Informal document **GRVA-07-48**  
7th GRVA, 21-25 September 2020  
Agenda item 8(c)

# UN Regulation No. 13-H Stop Lamp Illumination

Proposal for a Suppl.2 to UN-Regulation No. 13H/01

Supporting Presentation to Document  
**ECE/TRANS/WP.29/GRVA/2020/31**

## Shall illuminate

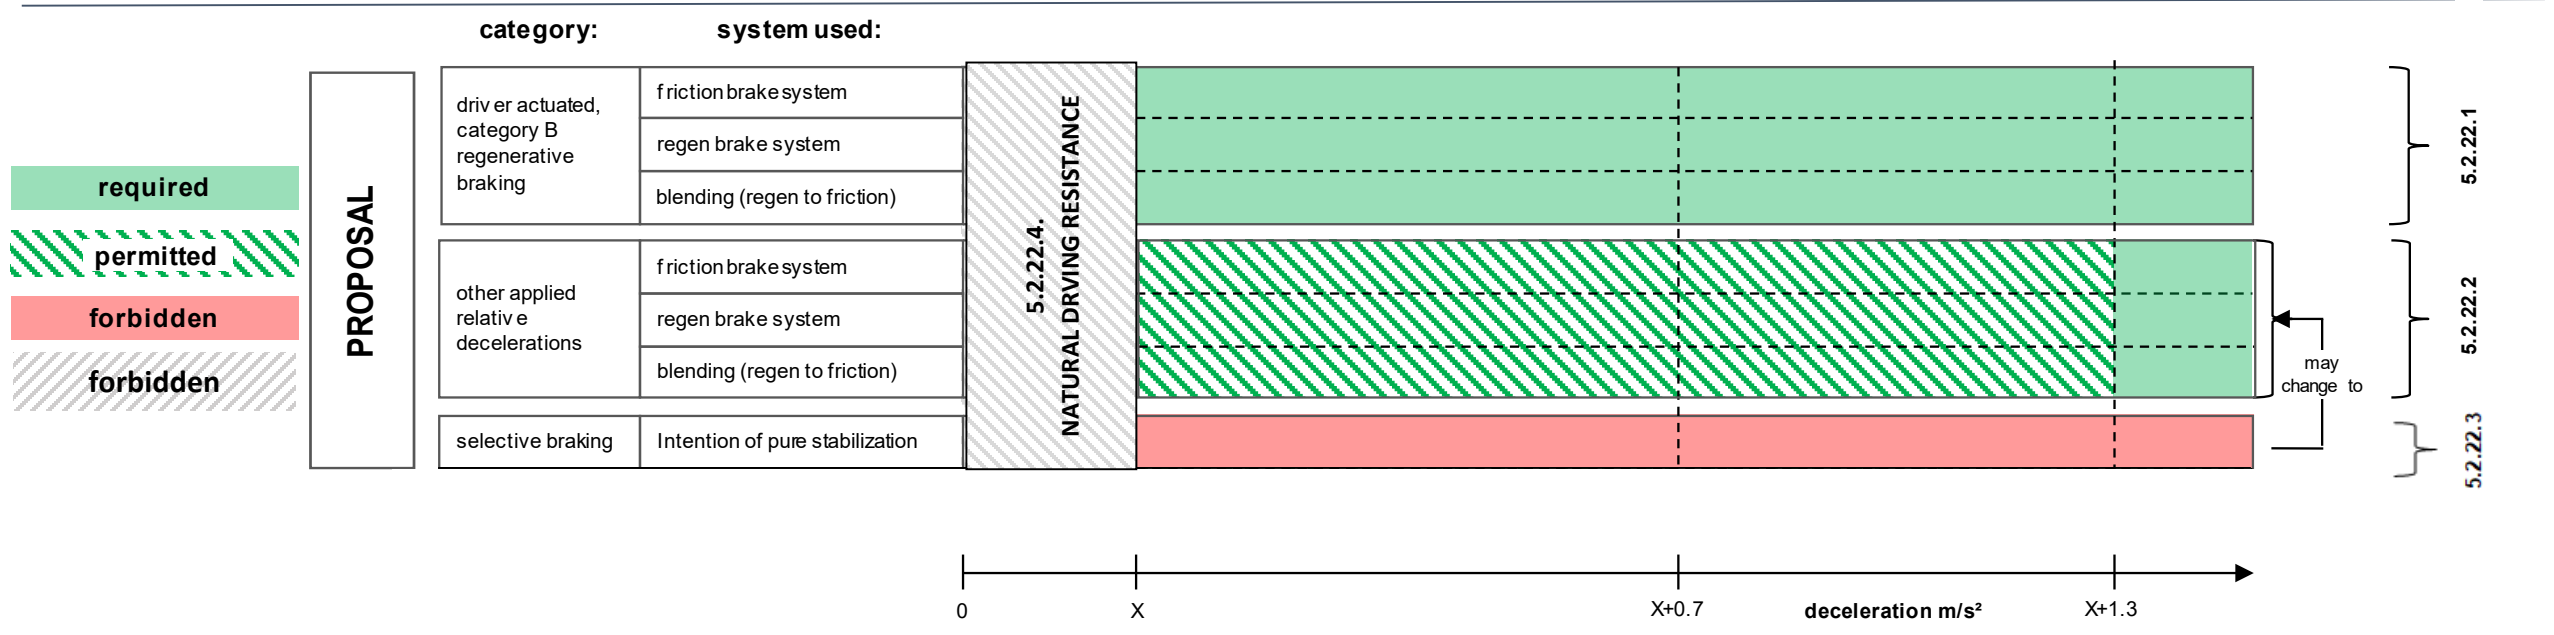
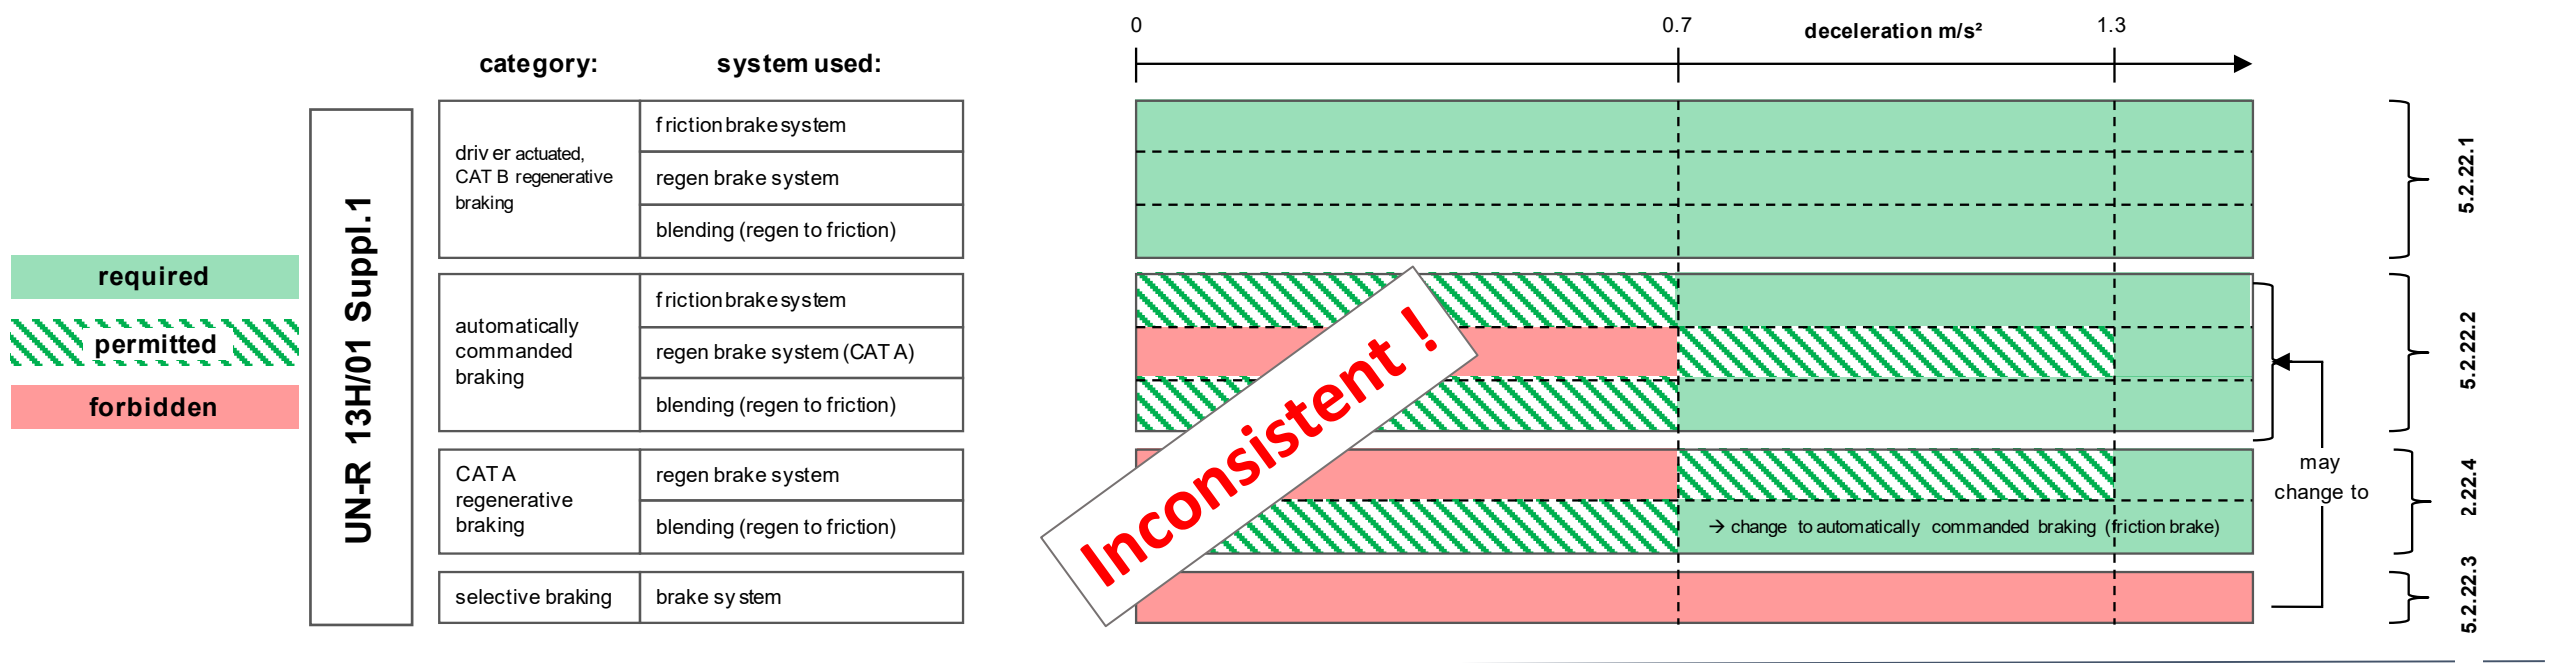
In cases where the intention to decelerate is obvious:

- Driver presses the brake pedal
- Driver releases the accelerator of an electric vehicle, generating noticeable deceleration ( $>1.3\text{m/s}^2$ )
- Automatically commanded braking is demanded (e.g. by AEBS, ACC...) and generating noticeable deceleration ( $>1.3\text{m/s}^2$ )

**The intention to decelerate is clear**
